## **MVP Southgate Project**

Docket No. CP19-14-000

## **May 2019 Supplemental Filing Attachments**

## **Changes to the MVP Southgate Project Workspaces and the Pipeline Route Table and Figures**

Sheet 3 of 13

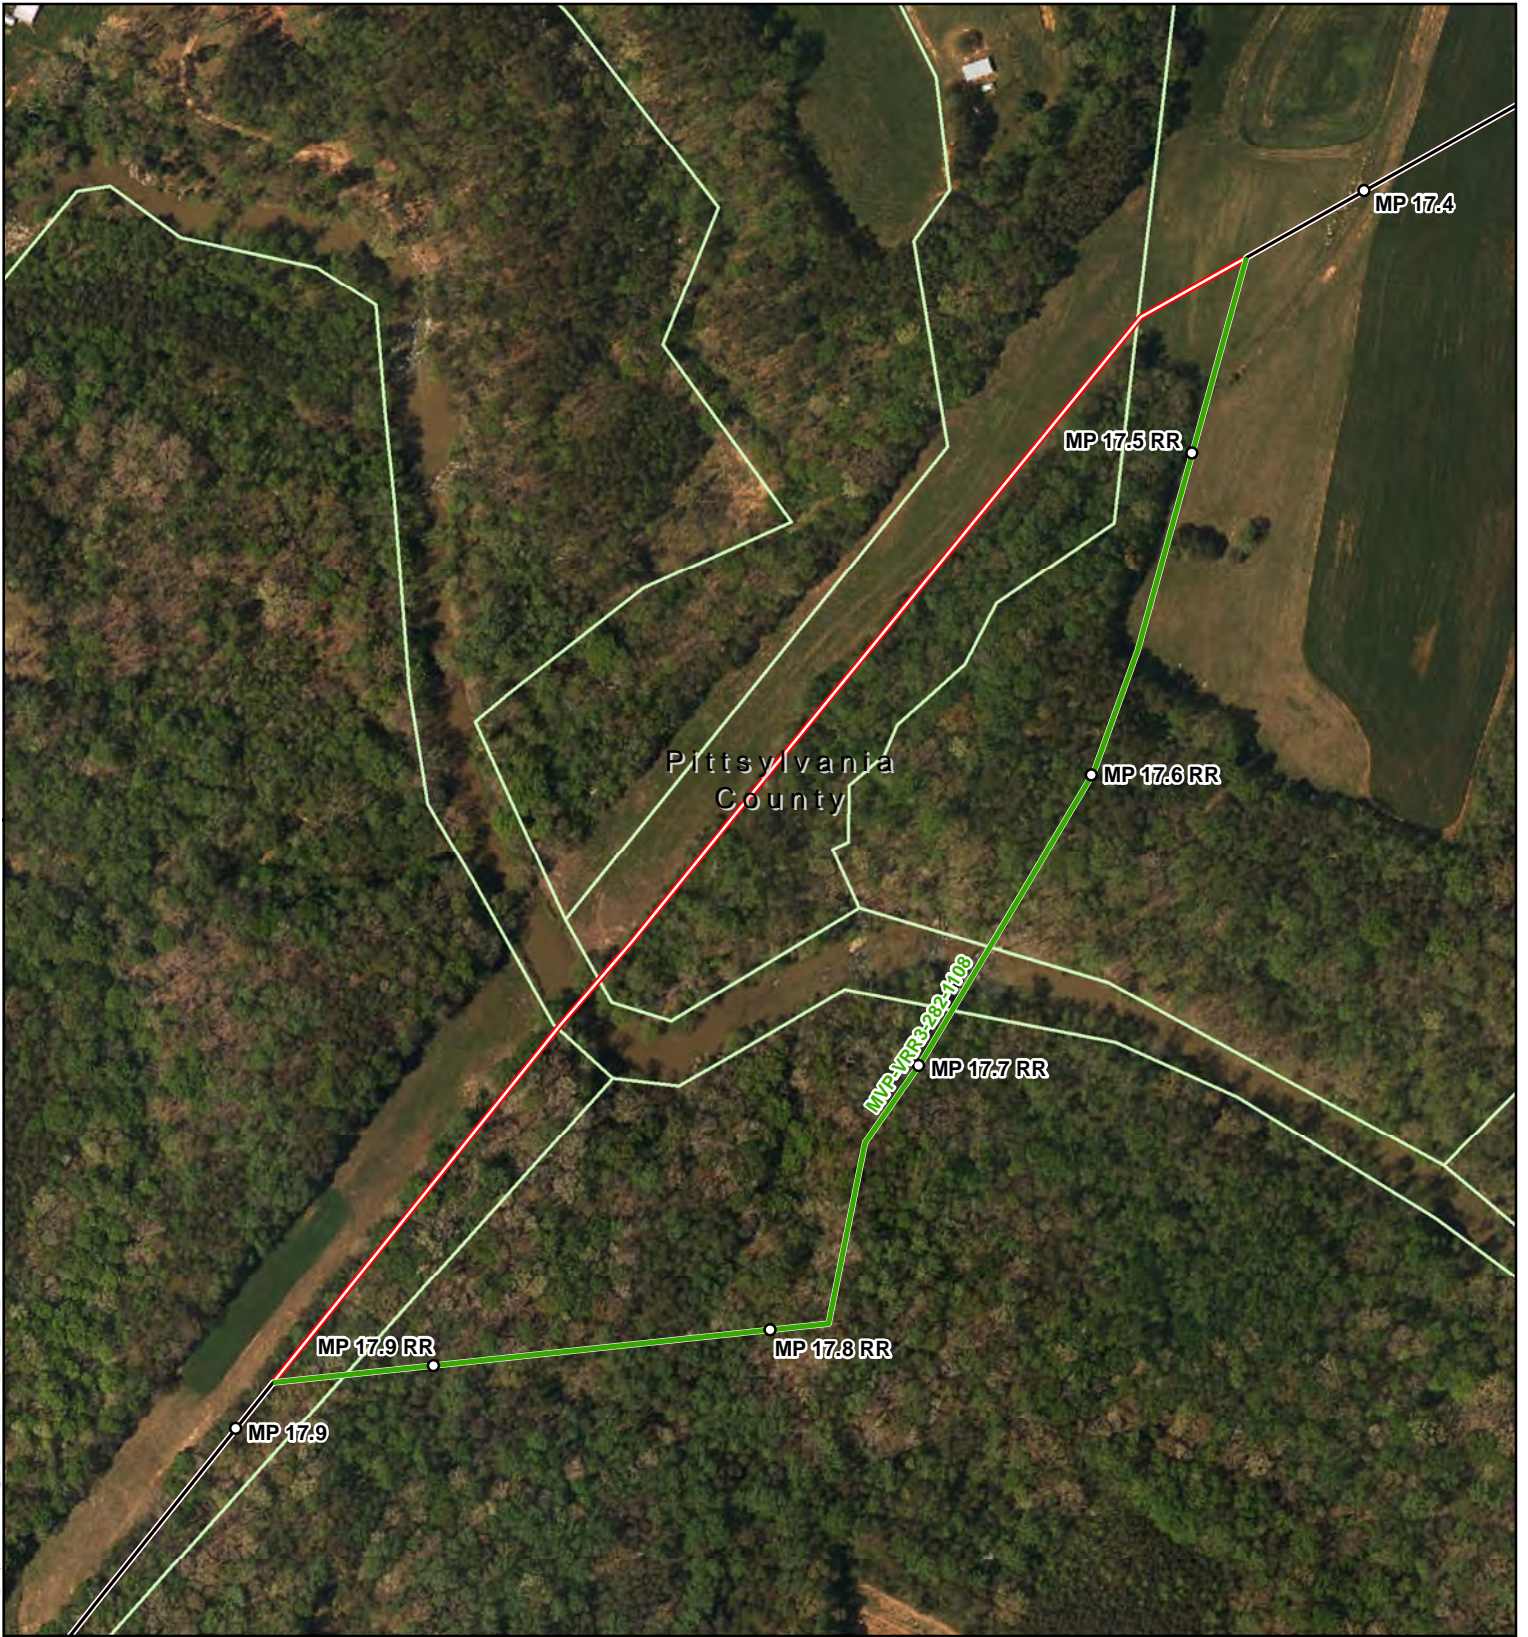
Modification: MVP-VRA3-114-1552

Sheet 9 of 13

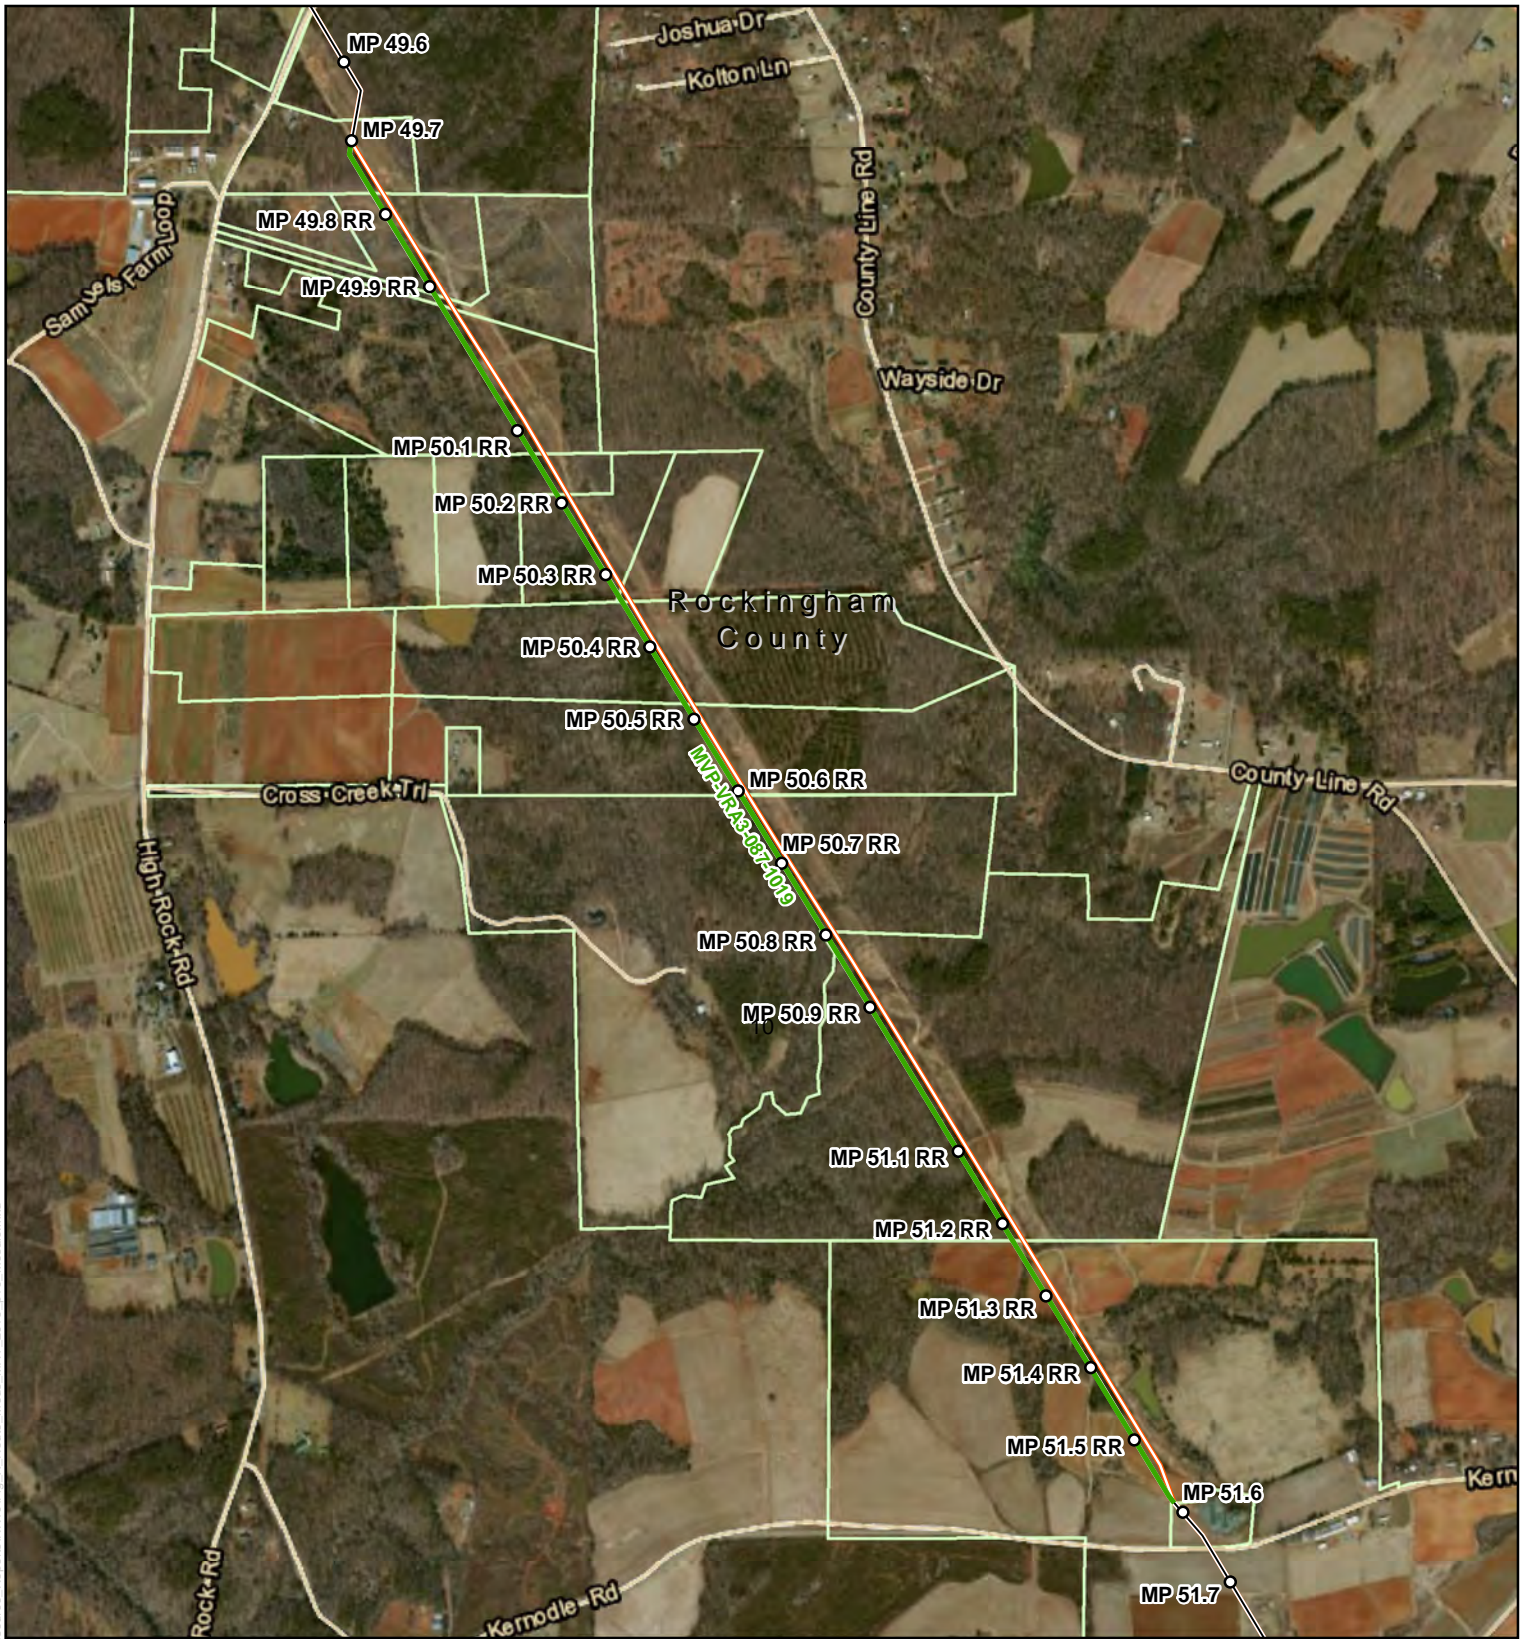
Modification: MVP-VRR3-080-1329

**Figure 1**  
Sheet 1 of 1

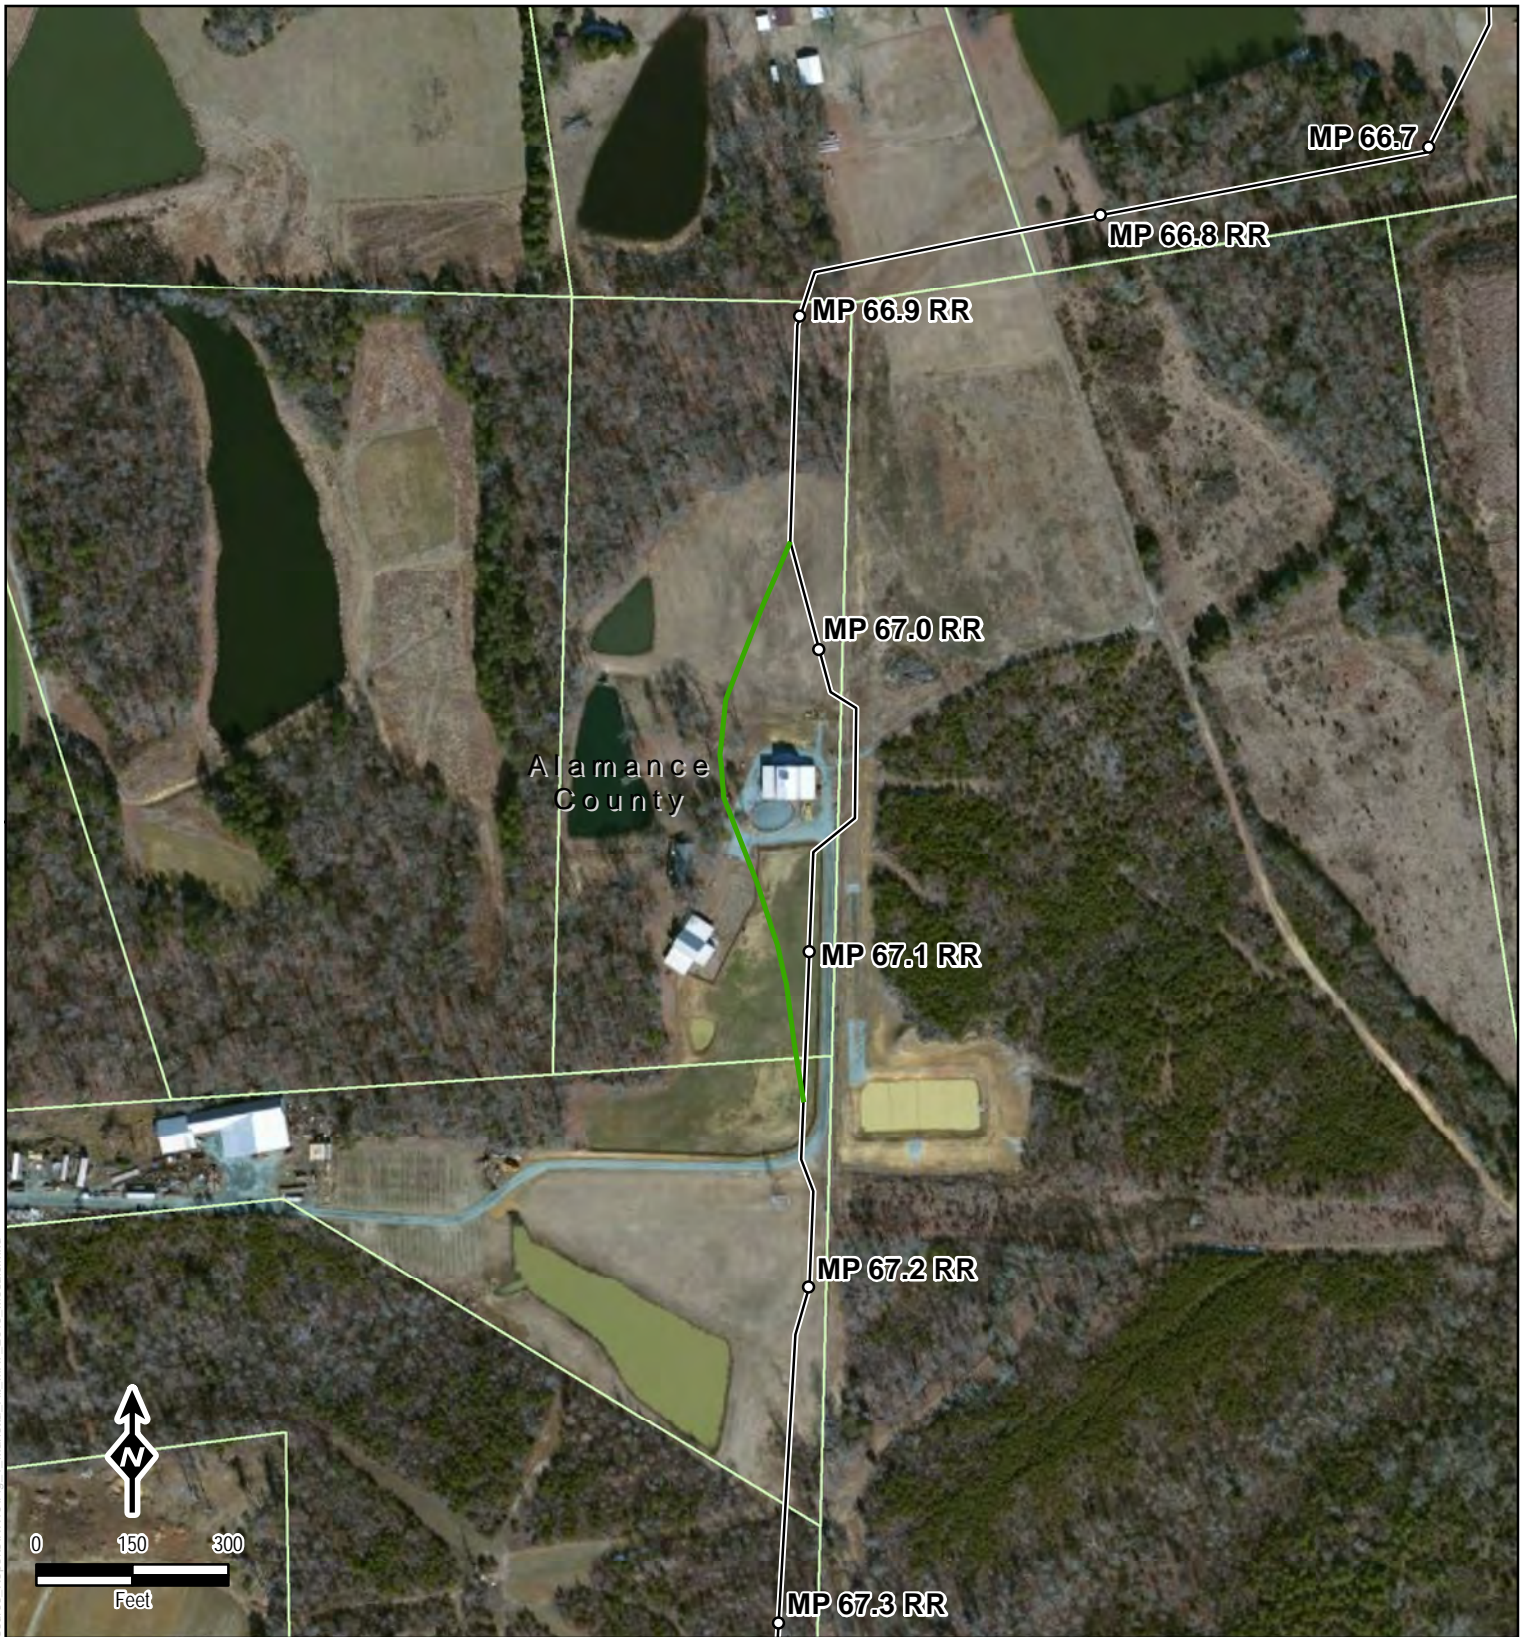
The Project evaluated a route variation that would relocate the current pipeline route to the west, further from the East Alamance Quarry, which is owned and operated by Martin Marietta Materials Inc. The Project evaluated the Martin Marietta Variation 1 between approximate MP 66.96 and MP 67.12 (see Figure 1). At MP 66.96, this variation extends southwest and southeast for approximately 0.2 mile and crosses open land. It rejoins the current pipeline route at MP 67.12.

- residential site specific construction plans would be required due to close proximity to structures.

**Figure 2**  
Sheet 1 of 1

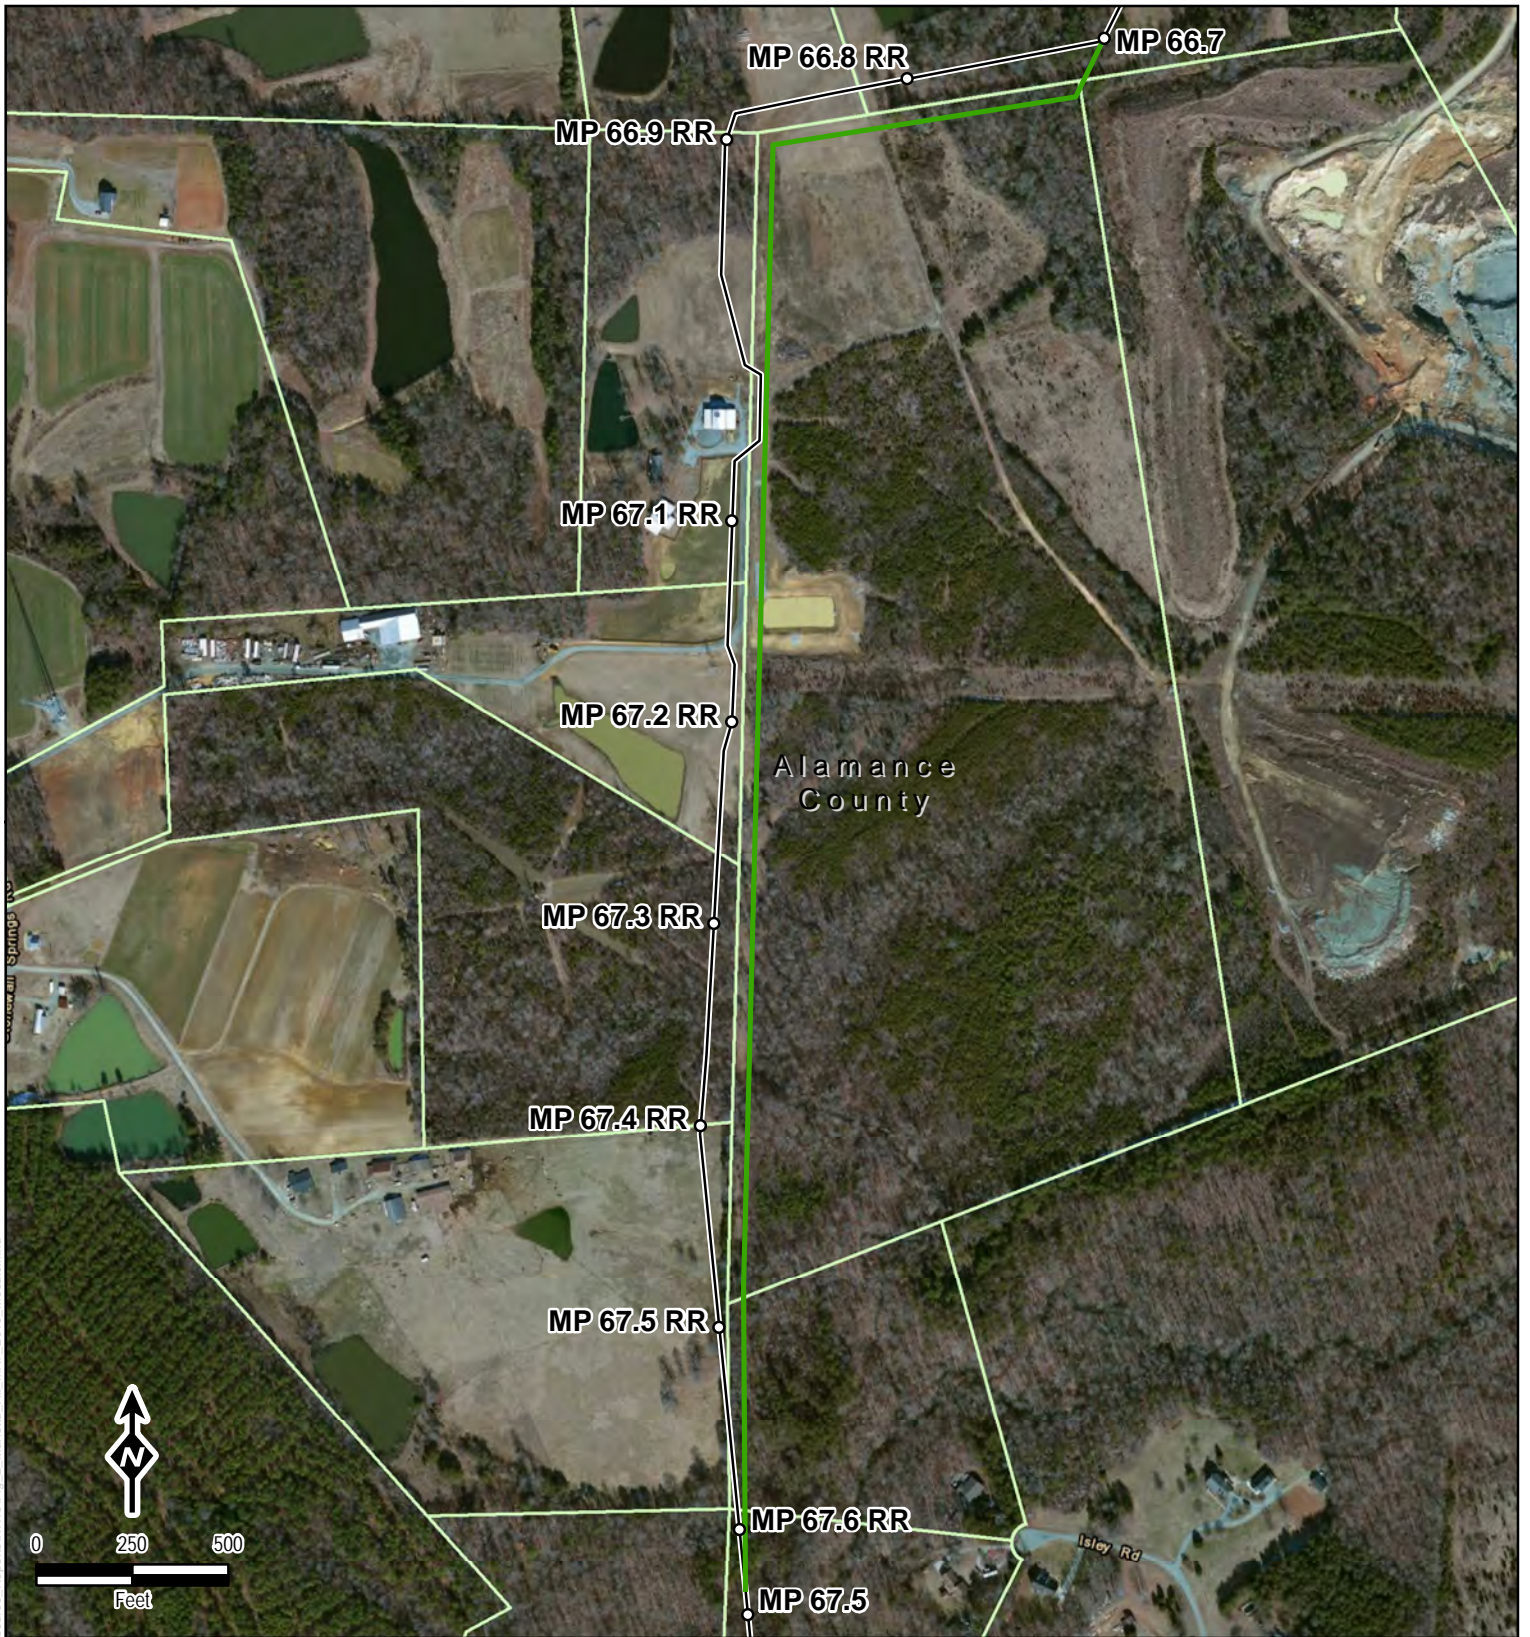
The Project evaluated a route variation that would relocate the current pipeline route approximately 100 feet to the east. The Project evaluated the Martin Marietta Variation 2 between approximate MP 66.7 and MP 67.5 (see Figure 2). At MP 66.7, this variation extends southwest for approximately 0.2 mile and crosses mixed forest and open/agricultural land. The route then turns more southerly for approximately 0.7 mile crossing mostly forested land, open/agricultural land, a man-made pond, and electric utility right-of-way before it rejoins the current pipeline route at MP 67.5.

Potential constructability concerns of the Martin Marietta Variation 2 are:

- potentially impacts man-made drainage system and pond.

The Martin Marietta Variation 2 does not offer a significant environmental advantage over the current pipeline. The Project is committed to finding the most appropriate route to minimize impacts to the quarry.
